Access Compliance Report

Public Rights-of-Way

(Curb Ramps)

Intersection ID: 28255	Main Street: REA_RD	Cross Street: ARDREY_KELL_RD	Location: SW
ADA ID: B2A301D685E4	Ramp Type: Perp	Initial Pass/Fail: Fail	Overall Compliance: No
Severity Score: 21.25			
Codes/Mitigation Info/Possible Solution		Field Measurements/Component Compliance

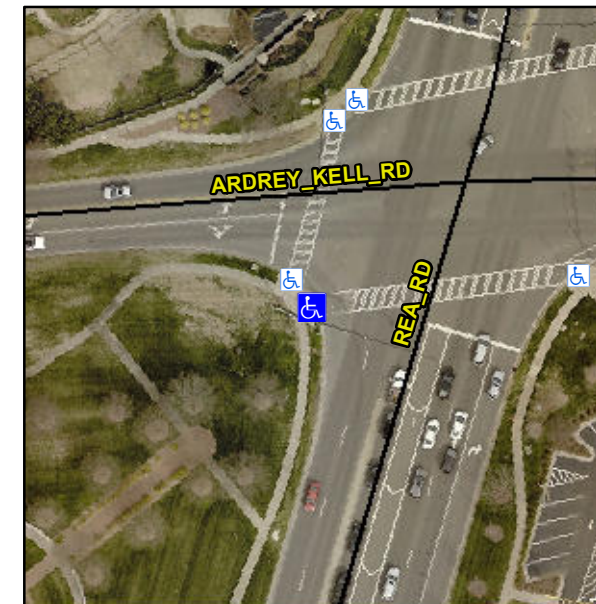
R304.5.1, R304.2.2

Compliance	Description	Data	Compliance	Description	Data
N/A	Ramp Length (in)	79.0	No	Ramp Slope (%)	10.3
No	Ramp Width (in)	37.0	Yes	Ramp XSlope (%)	1.5
N/A	Flare Type LT	N/A	N/A	Flare Type RT	N/A
N/A	Flare Slope LT (%)	N/A	N/A	Flare Slope RT (%)	N/A
N/A	Flare Traversable LT?	N/A	N/A	Flare Traversable RT?	N/A
N/A	Landing Length (in)	N/A	N/A	DWS Provided?	N/A
N/A	Landing Width (in)	N/A	N/A	DWS Contrast?	N/A
N/A	Landing Slope (%)	N/A	N/A	DWS Length (in)	N/A
N/A	Landing X Slope (%)	N/A	N/A	DWS Full Width?	N/A
N/A	Landing Curb? (Y/N)	N/A	N/A	DWS Offset (in)	N/A
N/A	Shared Landing?	N/A			
N/A	Gutter Ponding?	N/A	N/A	Gutter Slope (%)	N/A
N/A	Gutter Lip Ht (in)	N/A	N/A	Gutter X Slope (%)	N/A
N/A	Painted X Walk1?	Yes	N/A	Painted X Walk2?	N/A
	X Walk 1 Direction	To NE		X Walk 2 Direction	N/A
N/A	X Walk 1 Width (in)	123.0	N/A	X Walk 2 Width (in)	N/A
	X Walk 1 Slope (%)	1.8		X Walk 2 Slope (%)	N/A
	X Walk 1 X Slope (%)	2.5		X Walk 2 X Slope (%)	N/A

Remove & Replace Entire Ramp.
